SUBJECT: NuScale Power, LLC Submittal of Presentation Materials Entitled "NRC Public Meeting Presentation: Boron Redistribution and Associated Design and DCA Changes," PM-0620-70336, Revision 0

NRC Public Meeting Presentation

Boron Redistribution and Associated Design and DCA Changes

Design Changes (continued)

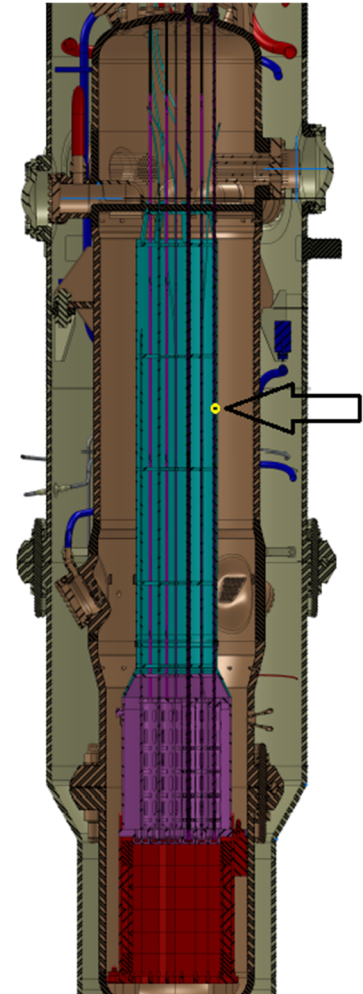
- Addition of ECCS actuation signal on low RCS WR pressure (less than 800 psia +/- 100 psi)
 - ECCS actuation prevented by either of following interlocks
 - CNV pressure less than 1 psia
 - RCS T_{hot} less than 475 °F
- Interlocks prevent ECCS actuation for Non-LOCA events
 - RCS is subcooled in DHRS cooldown events (lower than 475 °F) and have no increase in CNV pressure
 - Postulated MSLBs and FWLBs
 - RCS pressure remains above ECCS actuation pressure range during initial transient response
 - RCS is subcooled below 475 °F T_{hot} interlock before RCS depressurizes to ECCS actuation range

Safety Analysis

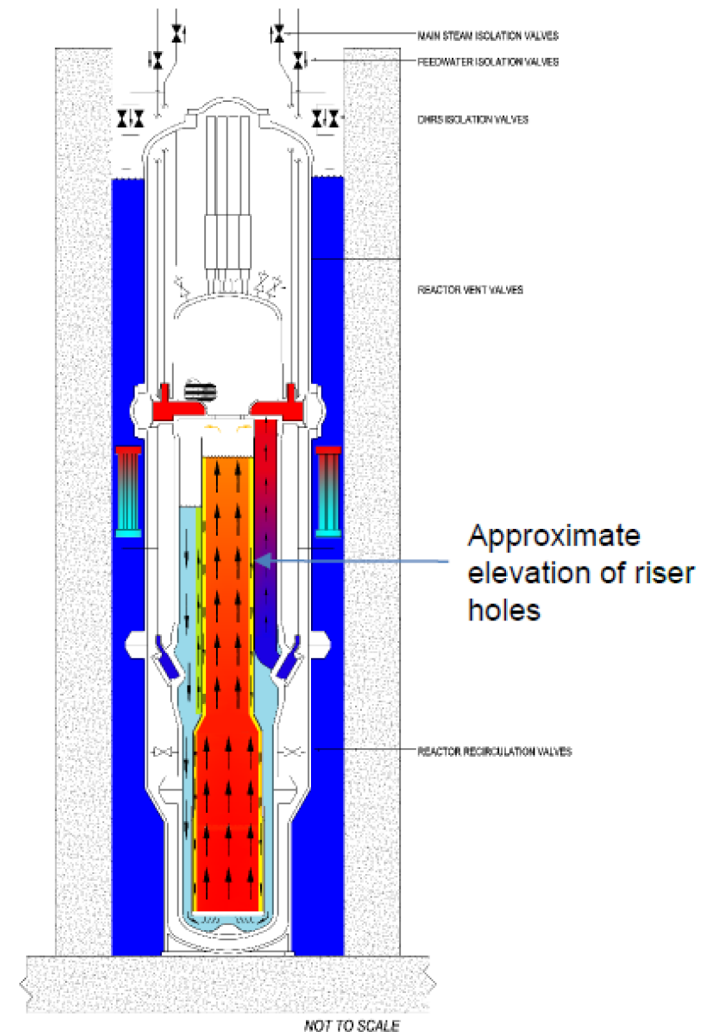
- Return to Power (FSAR 15.0.6)
 - End of cycle conditions remain limiting
 - No impact to the postulated limiting return to power scenario
 - Flow through riser holes maintains downcomer greater than critical boron concentration for events earlier in cycle
- Boron redistribution (RAI 8930)
 - Design Changes maintain assumptions in redistribution analysis
- LOCA (FSAR 15.6.5)
 - Some postulated events would actuate ECCS on low RCS pressure (most steam space LOCAs and some liquid space LOCAs)
 - No change to limiting event MCHFR or collapsed liquid level
 - Minor changes to some non-limiting events
